- **CALIBRATION—MAXIMUM SPEED RECALIBRATION TO 126 MPH (202 KM/H)—CROWN VICTORIA POLICE VEHICLES BUILT THROUGH 7/30/1999 ONLY**
- **TRANSMISSION—4R70W—VIBRATION/FLUID LEAK AT EXTENSION HOUSING—CROWN VICTORIA POLICE VEHICLES BUILT THROUGH 7/30/1999 ONLY**

**Article No.
99-18-1**

FORD: 1999 CROWN VICTORIA

Figure 1 - Article 99-18-1

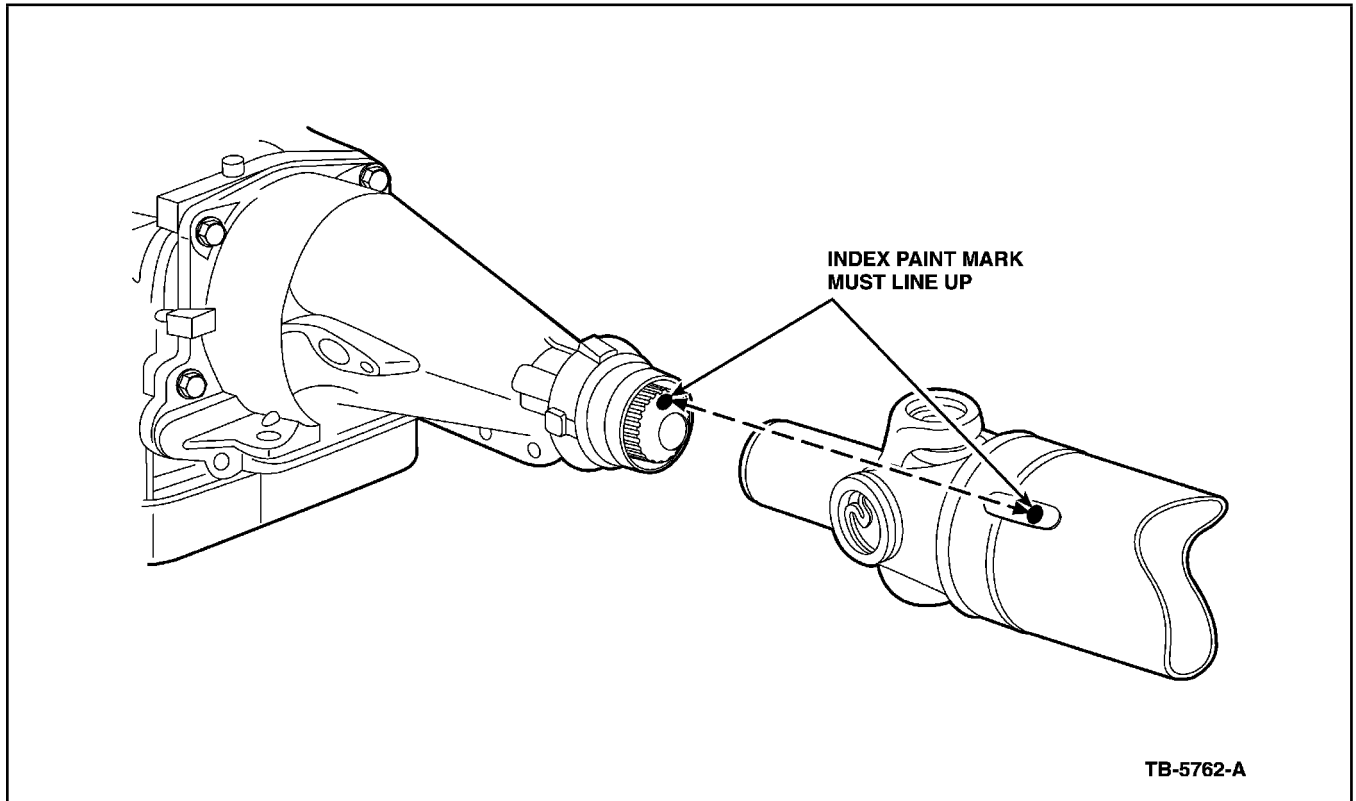
THE INDEX MARKS ON THE OUTPUT SHAFT, DRIVESHAFT, AND REAR AXLE MUST BE ALIGNED. THE BALANCE MARK ON THE OUTPUT SHAFT AND THE BALANCE MARK ON THE DRIVESHAFT MUST BE ALIGNED (FIGURE 1). FURTHER, ALIGNMENT OF THE INDEX MARKS ON THE REAR DRIVESHAFT TUBE AND REAR AXLE FLANGE MUST BE PERFORMED (FIGURE 2).
